STAFF REPORT

RZ 2014-BR-001

PROPOSAL: To rezone 42,209 sf from the R-1 to the R-3 District for the development of two single-family detached houses at a density of 2.06 dwelling units per acre.

TWINBROOK ROAD SUBDIVISION

GENERALIZED DEVELOPMENT PLAN (GDP) OPTION - I
5015 TWINBROOK ROAD, BURKE
FAIRFAX COUNTY, VA 22015
BRADDOCK DISTRICT

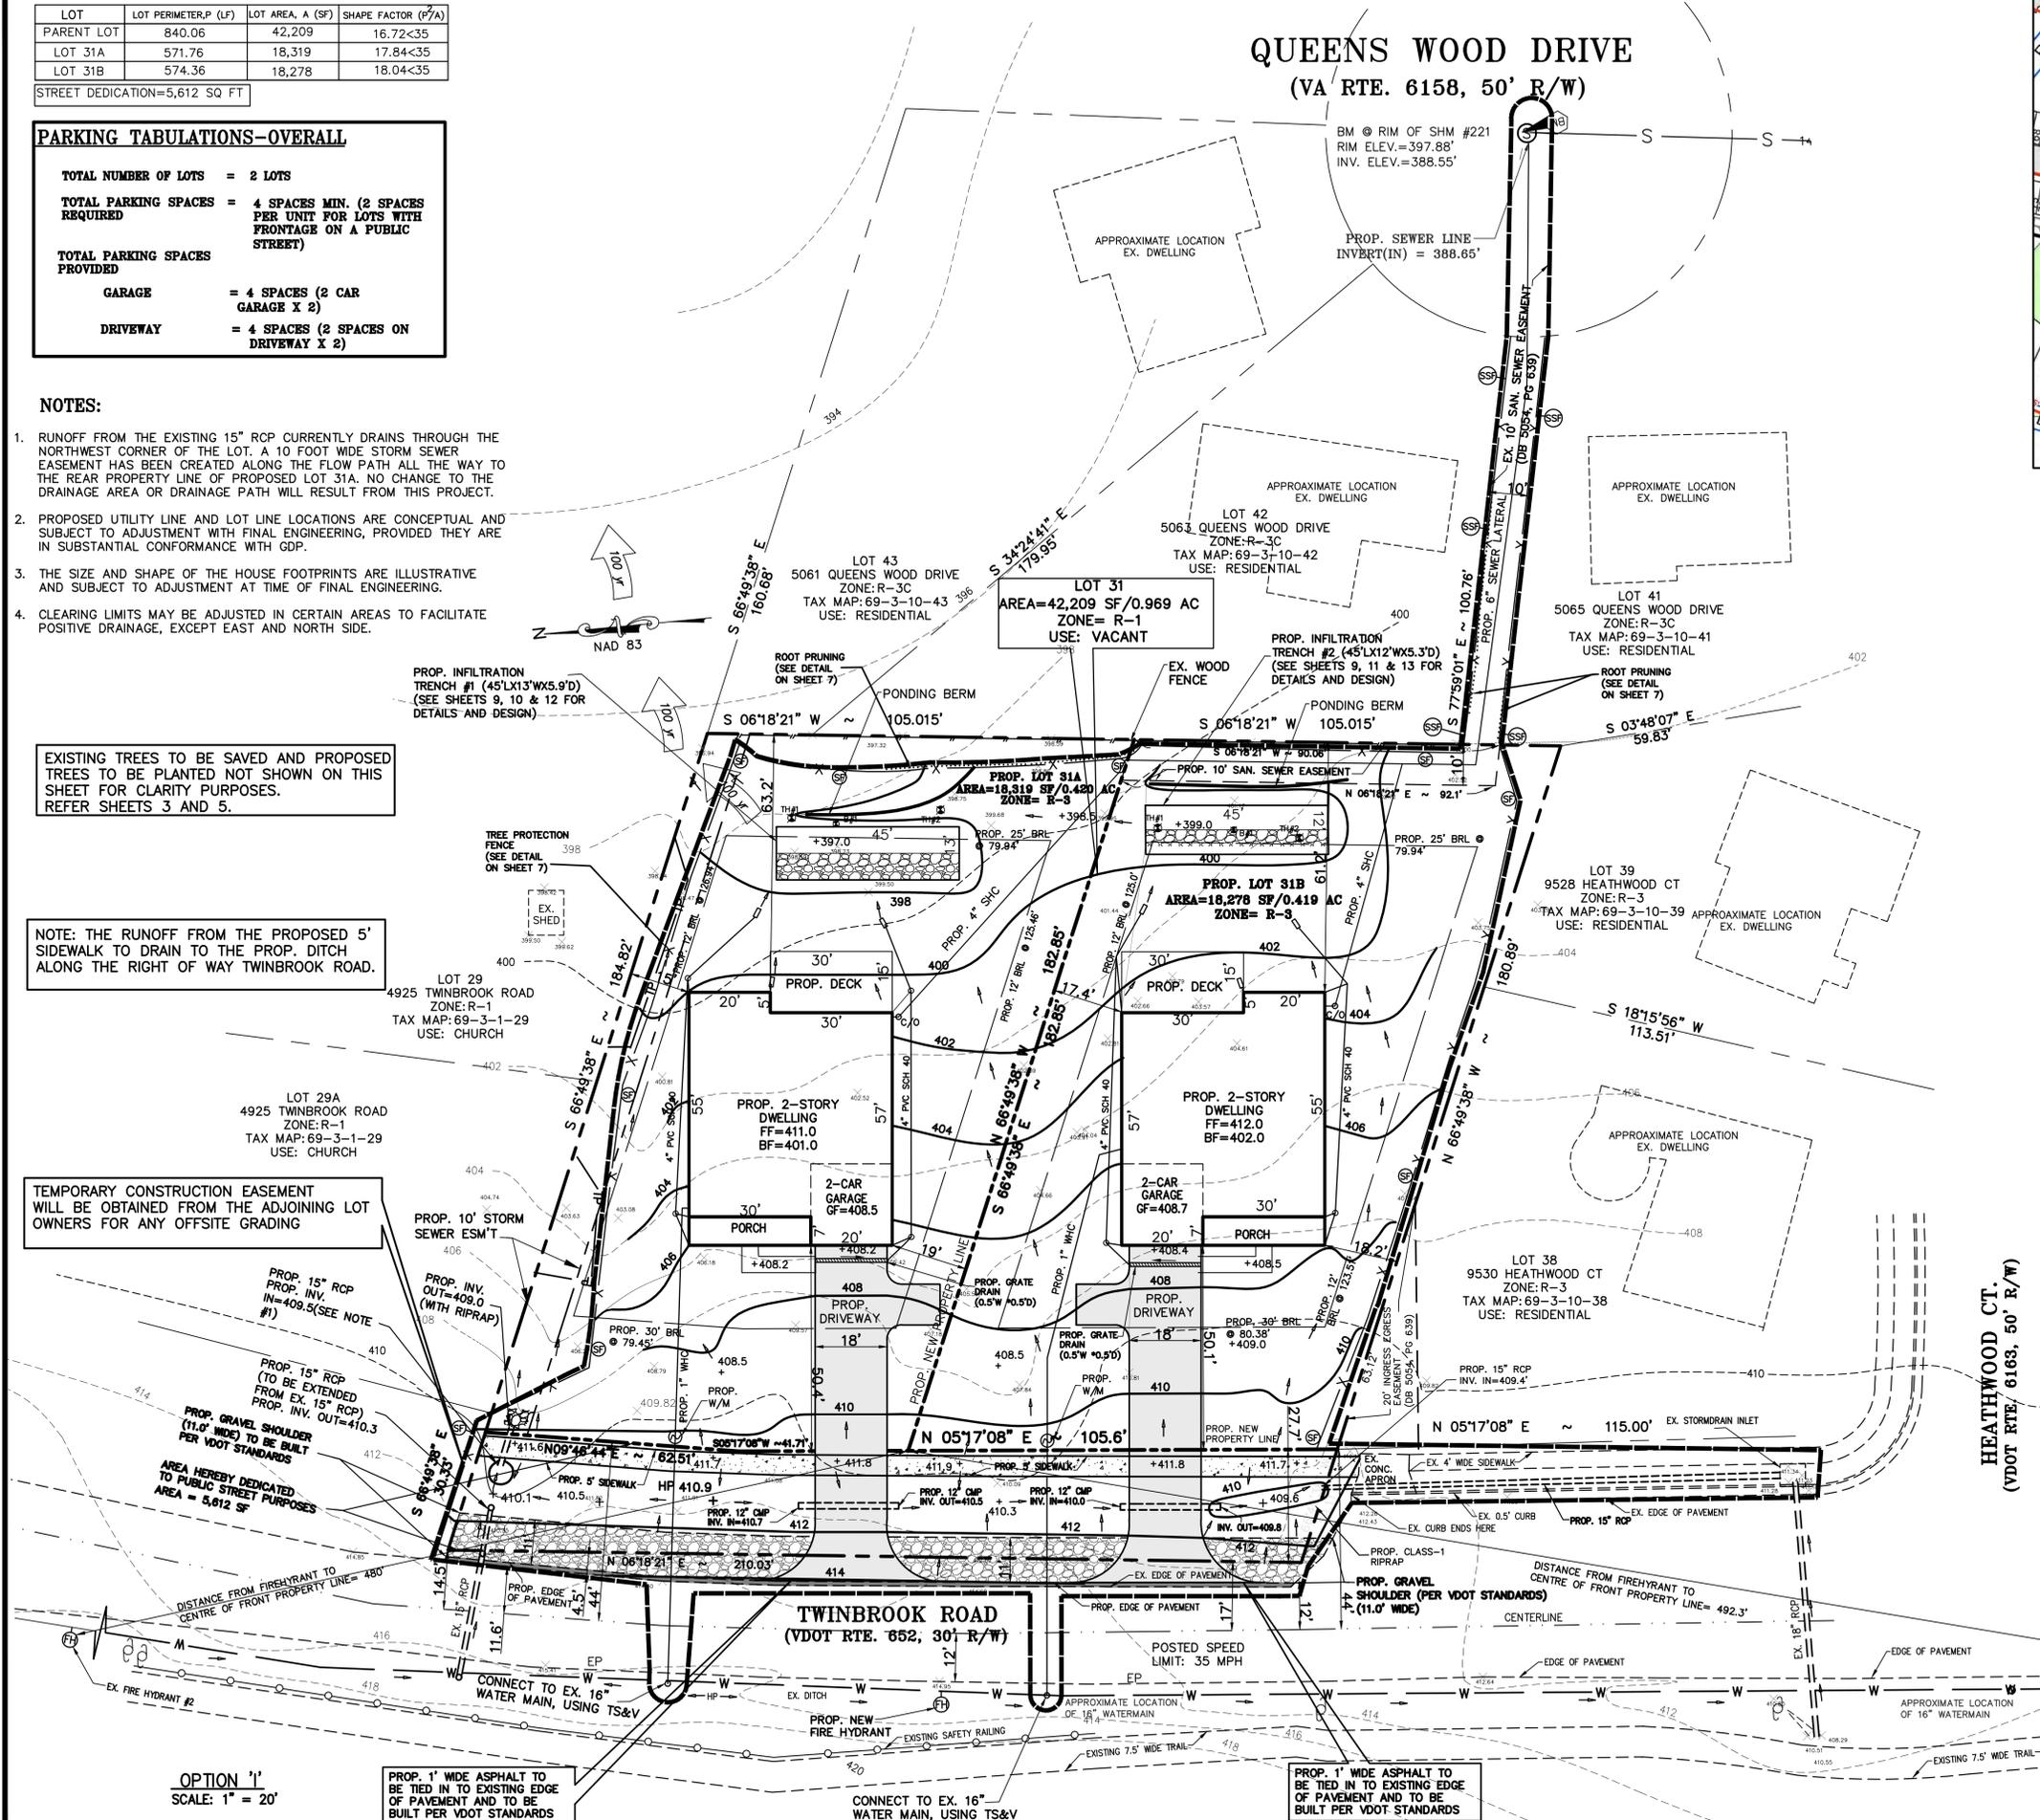
In response to staff comments, the applicant submitted a revised tree inventory that included off-site trees within 25 feet of the proposed limits of clearing and grading. Additionally, the applicant shifted the BMP facilities to the west and adjusted the limits of clearing and grading, to provide additional protection for off-site trees. The applicant also provided information on Sheet 5 of the GDP regarding tree protection measures to be taken during the installation of the off-site sanitary sewer connection, which runs southeast of the site to Queens Wood Drive.

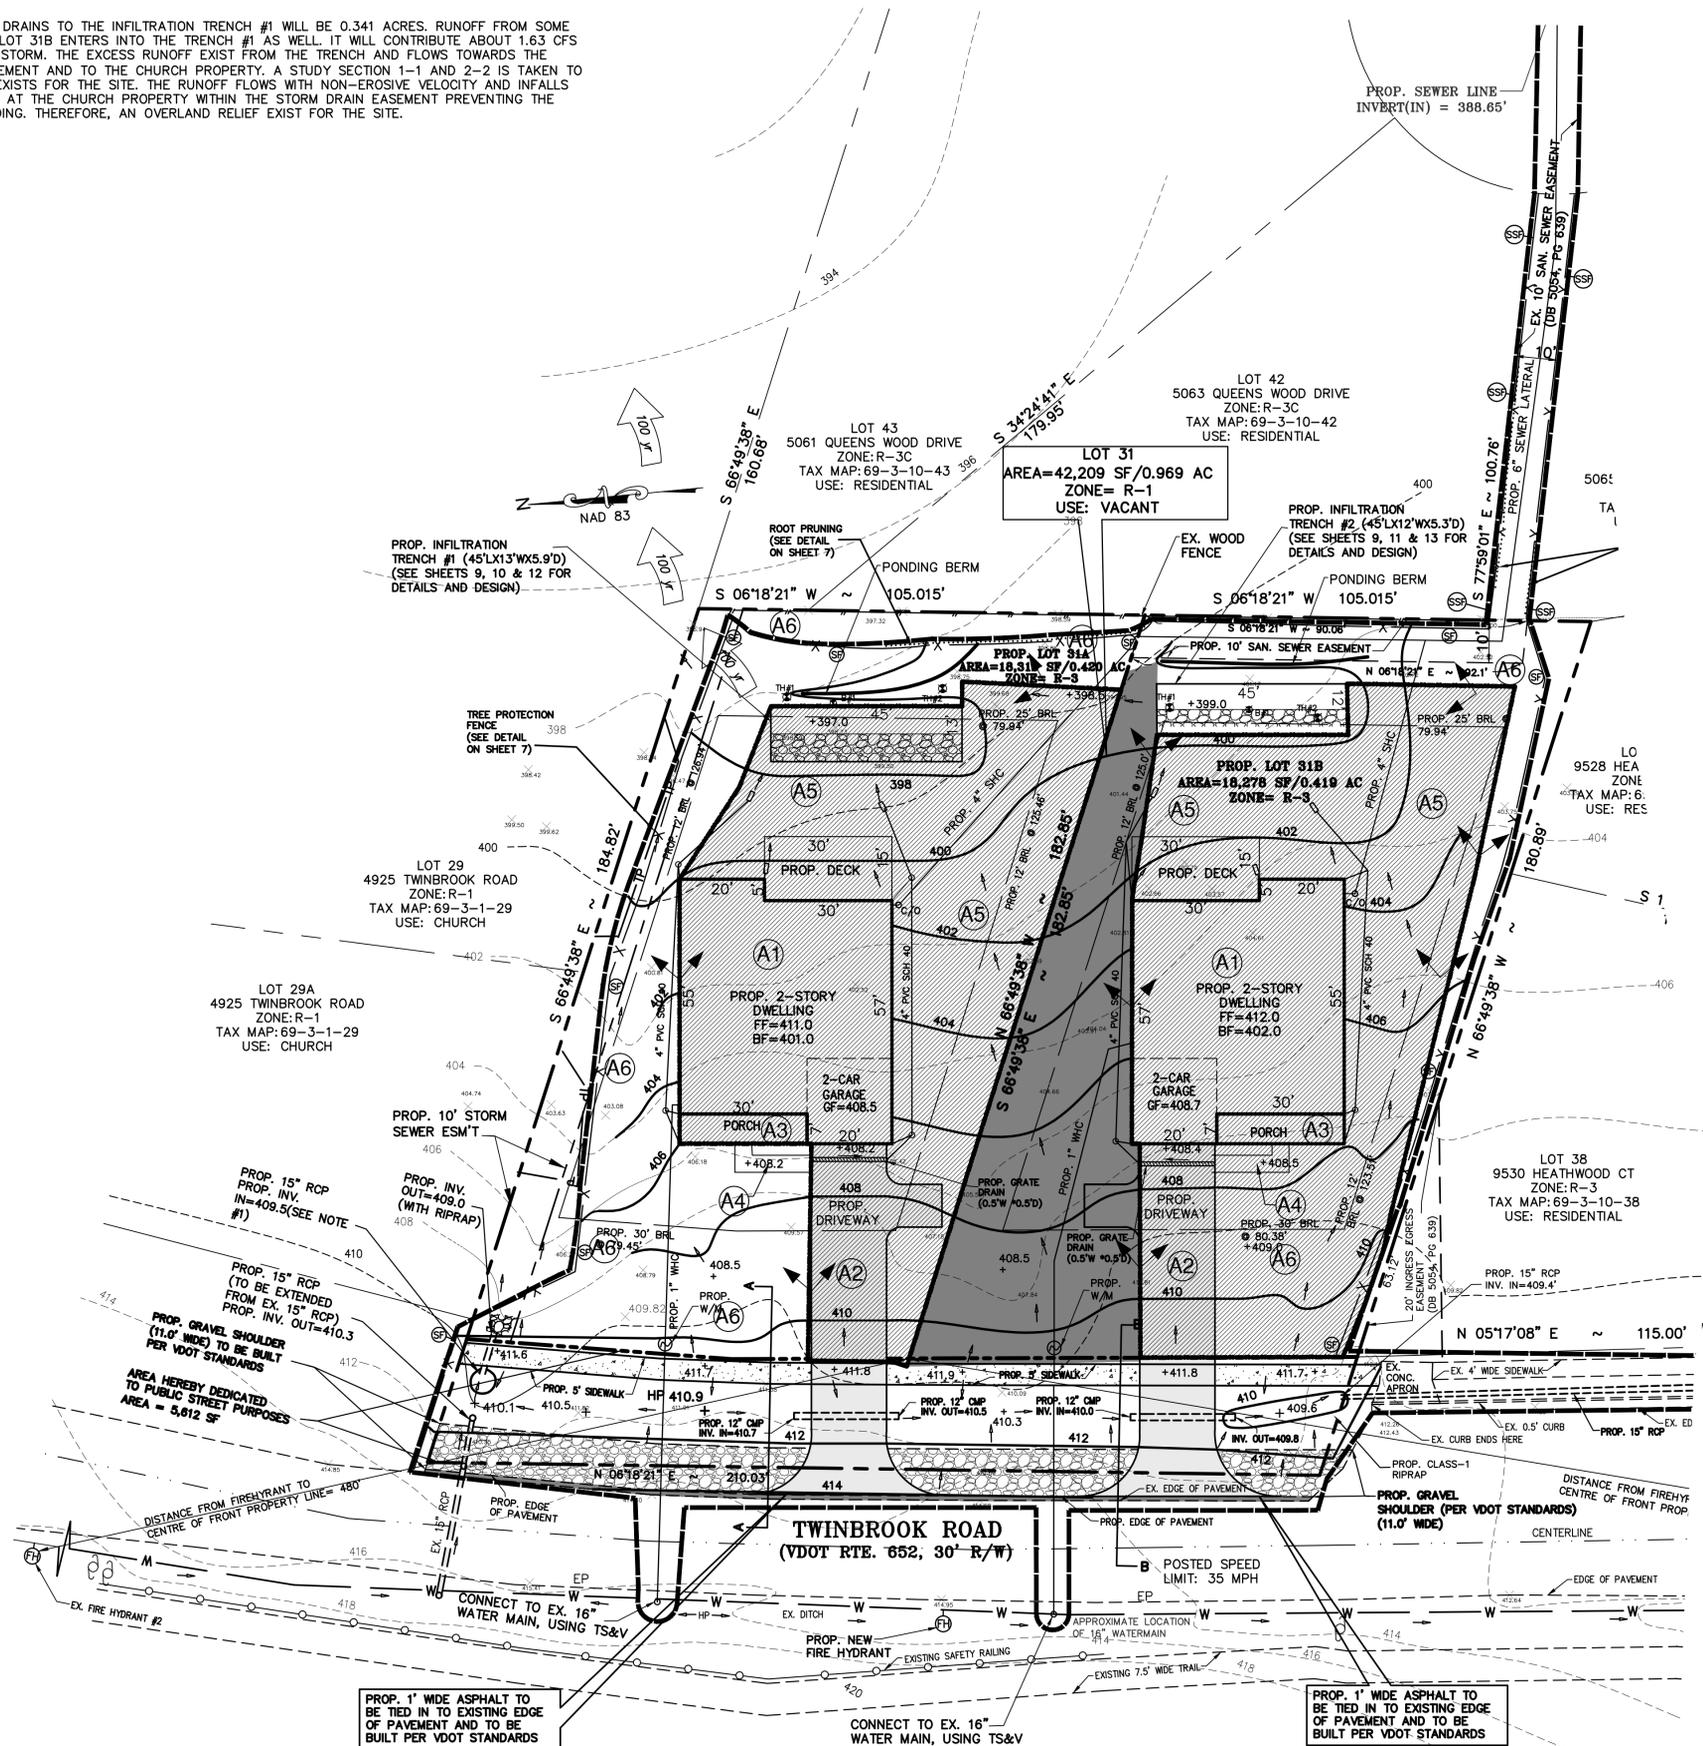
The Stormwater Information Sheet provided on Sheet 11 of the plan set will need to be corrected and updated for this project.
